**PARKMOUNT ROAD : MOUNTJOY AVENUE - FELSTEAD AVENUE
PROPOSED TRAFFIC CALMING**

Brian Holditch
Transportation Technologist
17th Floor, Metro Hall
55 John Street
Toronto, Ontario M5V 3C6**Re: Traffic Calming Measures – Parkmount Road, between Felstead Avenue and Mountjoy Avenue – Evaluation for the Installation of Speed Humps**

Re: Traffic Calming Measures – Parkmount Road, between Felstead Avenue and Mountjoy Avenue – Evaluation for the installation of speed humps.

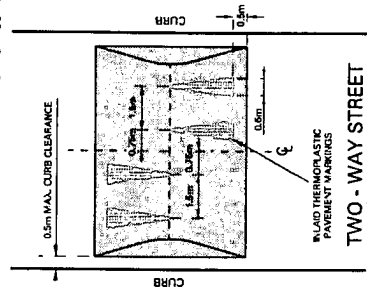
Fire Services is opposed to this speed hump installation as they will slow our responding vehicles and affect our ability to deliver service in the quickest possible manner. The effectiveness of our services is directly proportional to the time it takes to receive notification, travel to the incident and begin operations. The vertical restrictions imposed by speed humps have a much greater effect on large fire vehicles than smaller passenger vehicles. Response time increases with every obstacle a fire vehicle encounters en-route from the fire station to the incident. Although the increase at each hump may only be seconds, the cumulative effect can be a significant amount of time. A thirty-second delay (3 to 4 humps) is enough to alter the outcome of an incident from a successful fire extinguishment with minimal property damage and rescue of all occupants to complete structure loss with fire fatalities.

It is imperative that the individuals directly affected by this installation be made fully aware of the potential negative effects of the proposed calming devices, particularly because **this application does not meet the criteria as set out in the policy for speed humps**. Careful consideration must be given to accepting delays of emergency response vehicles as a trade-off to combat the risks presented by regular vehicle traffic.

Fire Services recommends that non-physical measures (speed limits or prohibited turns) be implemented and evaluated before physical forms are considered. Desired results may be obtained without imposing a physical obstruction to emergency vehicles. The impact of a speed hump installed in a segment of a street is difficult to evaluate without accounting for all measures that exist on the surrounding streets. It is our opinion that traffic calming measures need to be evaluated on a network-wide basis to better assess the impact to the entire response area.

As documented in the in the Traffic Calming Policy, Toronto EMS has concerns regarding the usage of traffic calming measures, especially vertical obstacle measures such as speed humps, as there are negative effects on emergency call response times, travel times to hospital and on patient comfort during transport. This delay is cumulative with each obstacle and can directly impact upon patient outcome.

It is noted that this proposal does not meet the Warrant Criteria as set out in the Policy and as such, Toronto EMS is opposed to the installation of speed humps on Parkmount Road, between Felstead Avenue and Mountjoy Avenue. It is important that the applicant(s) fully understand the potential for delay in emergency response and that alternatives to vertical measures be considered and evaluated.
